APPLICATION TO DESIGN REVIEW COMMISSION

Amended Application 2: 4/30/18

Façade Remodel for: West Hill Plaza

West Ave. and Rte. 29, Saratoga Springs, NY 12866

NEW FLOOR PLAN
 SCALE 1/16" = 1'-0"

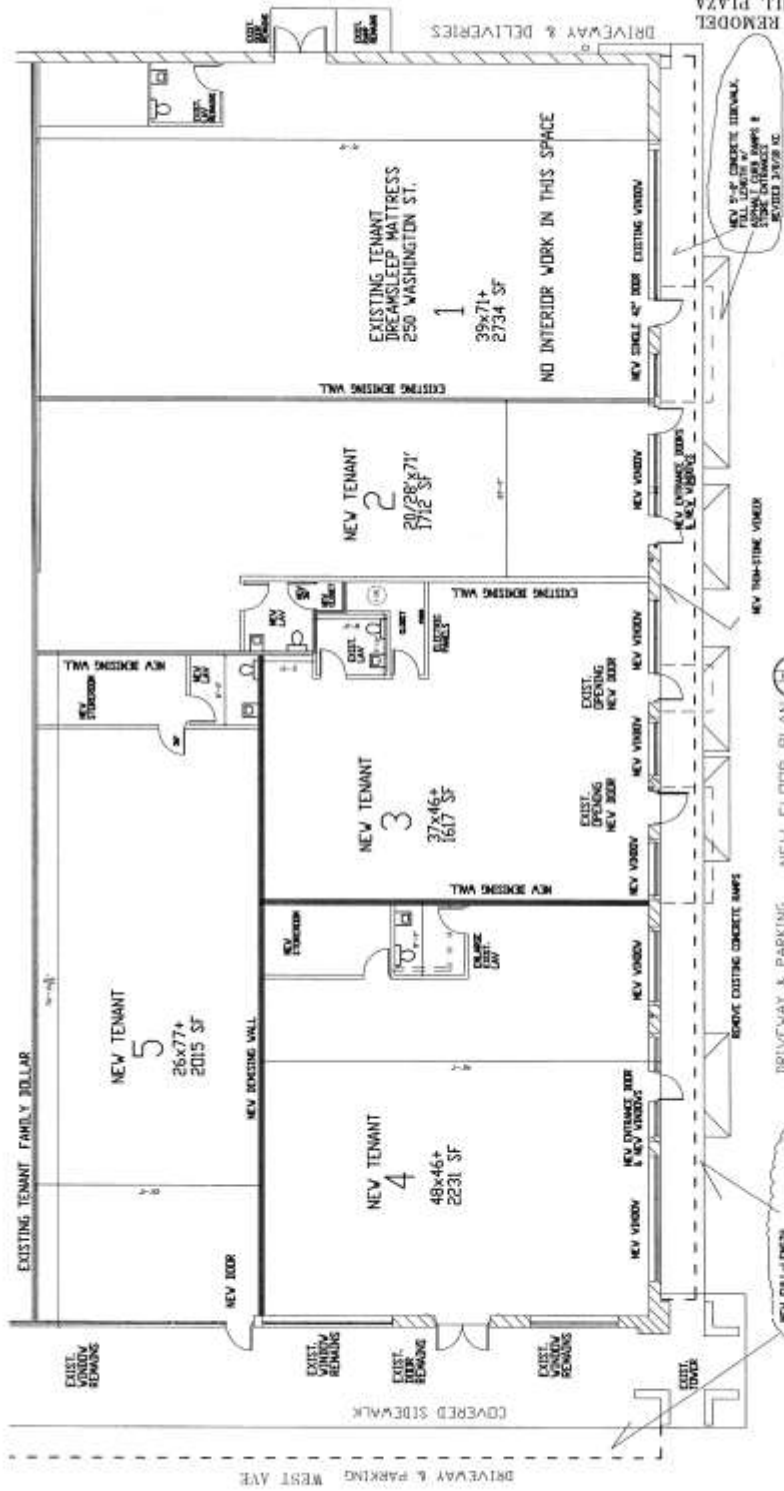
The only new proposal to amend the site plan is to add a new 5-foot wide sidewalk along the full-length of the Washington St. side, with new asphalt curb ramps at each store entrance door. This will replace the existing separate, short sidewalk sections and separate ramps. This will not restrict the driveway in this area, that will be over 24-feet wide after the sidewalk is added.

NEW FULL-LENGTH
 METAL AWNING
 ALUMINUM TUBE FRAMING
 REVISED 3/28/18 DC

NEW 2" CONCRETE TERRAZZO
 FULL LENGTH AT
 ALL EXISTING DOORS &
 NEW EXTERIOR DOOR
 REVISED 3/28/18 DC
